FIRE SAFETY INSPECTION REPORT

NEWAGE GARMENTS LTD.

April 17, 2014

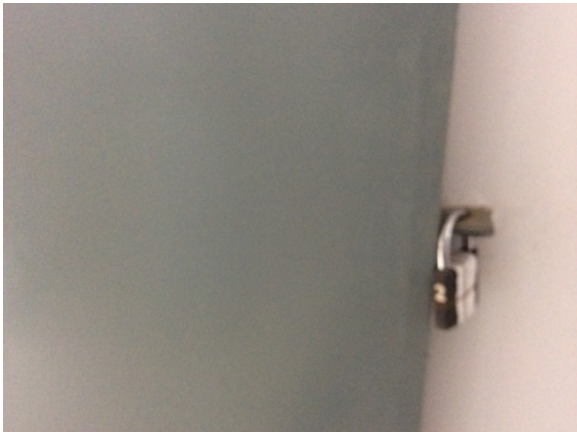
No.	Category	Finding	Recommendation	Remediation Timeframe
F-1	Fire Rated Construction	The exit stairs are not separated from work areas, other spaces on each floor by fire-rated construction.	Provide minimum 1.5-hr fire rated doors and seal all unprotected openings to separate the exit stairs from work areas and other building spaces on all floor levels. Ensure that the fire doors are self-closing and positive latching and that they are provided with fire exit (panic) hardware where serving production floors. If fire doors are required to be held open for functional reasons, provide automatic-closing devices tied to the fire alarm system.	Within 3 months

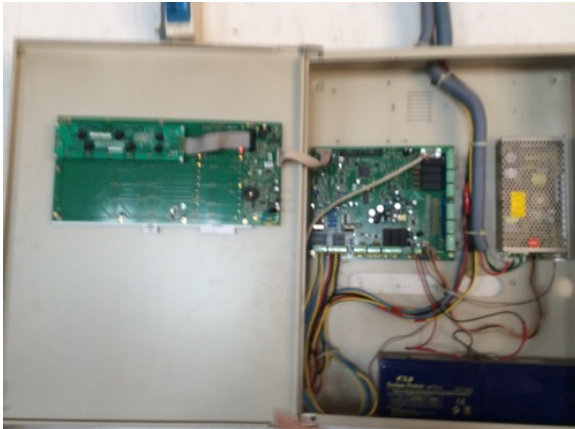
F-4	Egress	Storage was located on the ground floor of north eastern stair and north western stair.	Remove all storage from exit stairs and egress paths.	Immediate
-----	--------	---	---	-----------
